Warranty Bulletin

WB22-11A

Revision: A

F76 & F77 – INCORRECT FUSES INSTALLATION 9700 (B13R)

Figure 3

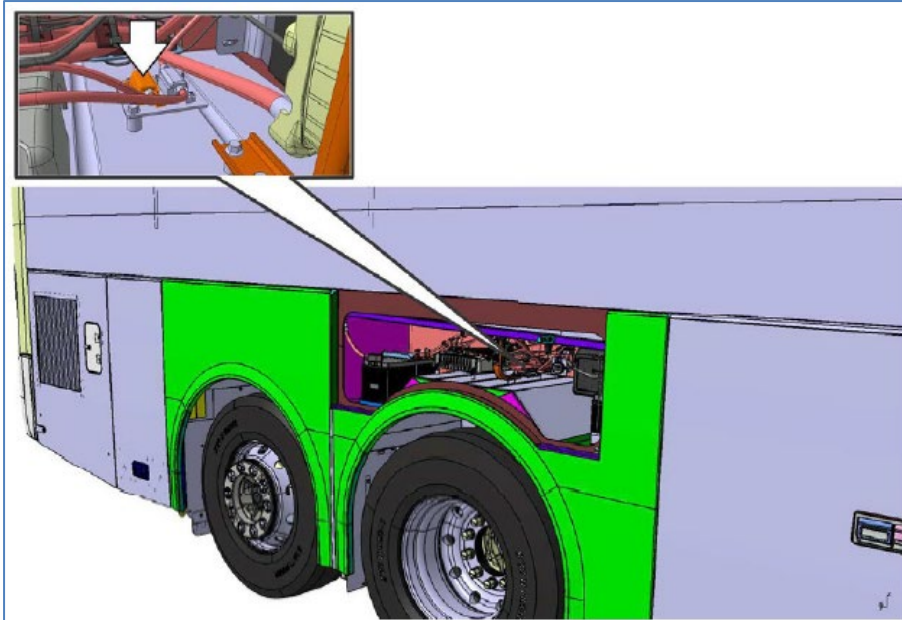
- 4) Remove the fuse cap from the fuse identified as F76 circuit.

Figure 4

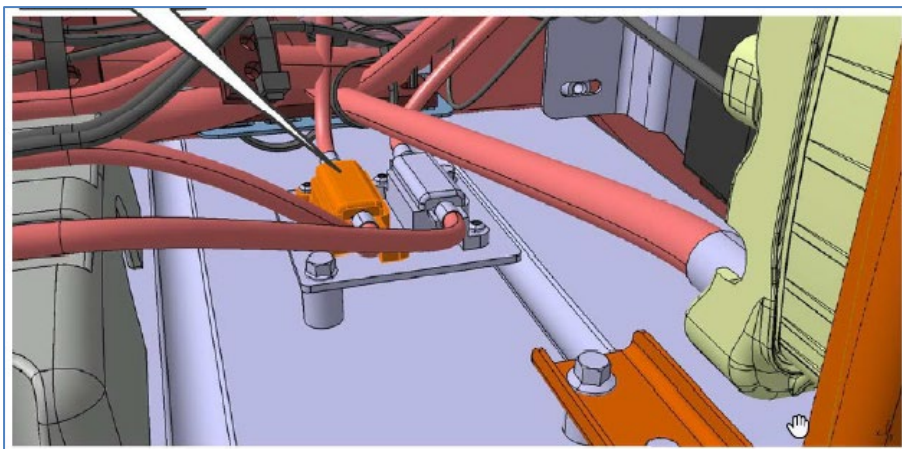
- 5) Check the F76 fuse capacity, that should be of **80 A**. In case of finding a different fuse value, remove it and change it for an 80 A fuse (p/n 992454).

For fuse install, apply thread locking fluid on the threads corresponding to fuse nut fittings.
SPECIFICATION: Tighten the fuse fixing nuts, applying the following torque: 15 +/- 3 N·m (11 +/- 2 lbf ft).

Figure 5

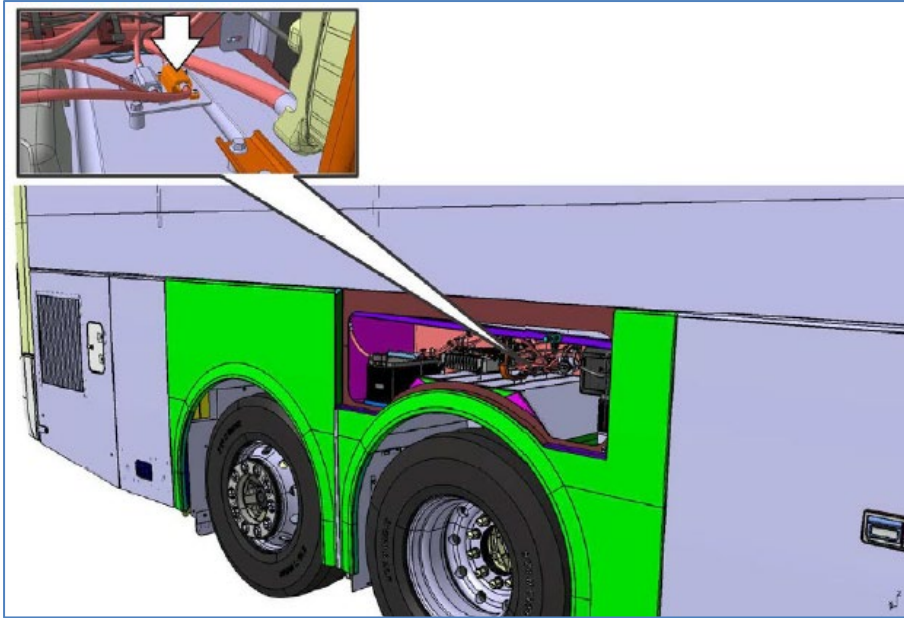
- 7) Remove the fuse cap from the fuse identified as F77 circuit folio.

Figure 6

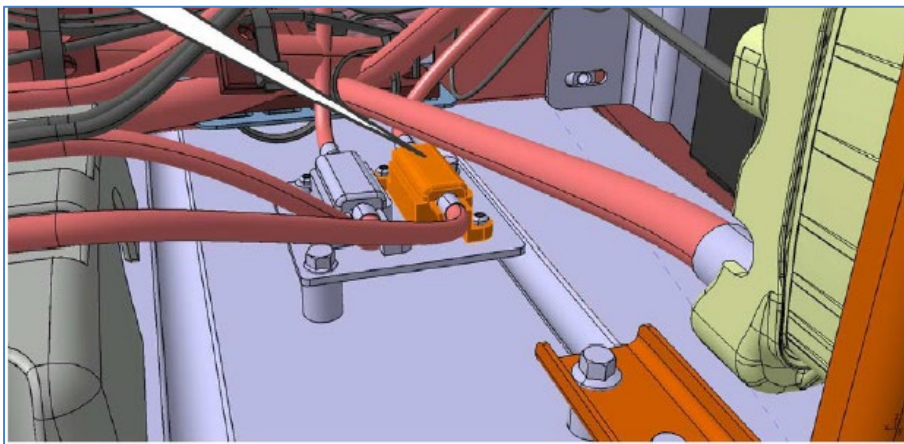
- 8) Check the F77 fuse capacity, that should be of 40 A. In case of finding a different fuse value, remove it and change it for a 40 A fuse (p/n 982317).

For fuse install, apply thread locking fluid on the threads corresponding to fuse nut fittings.
SPECIFICATION: Tighten the fuse fixing nuts, applying the following torque: 15 +/- 3 N·m (11 +/- 2 lbf ft).
